HlePRO B23001135

Koai'a Corridor Improvement Project – Driveway Hardening
Questions provided by bidders:

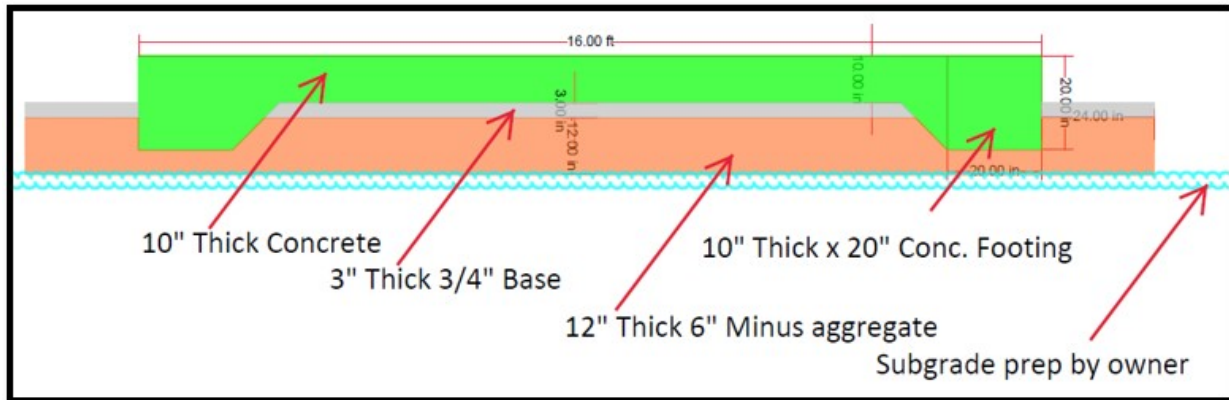
Q8) Is this what you have in mind for the Concrete pavement prism cross section?

A8: Yes, that diagram is correct.
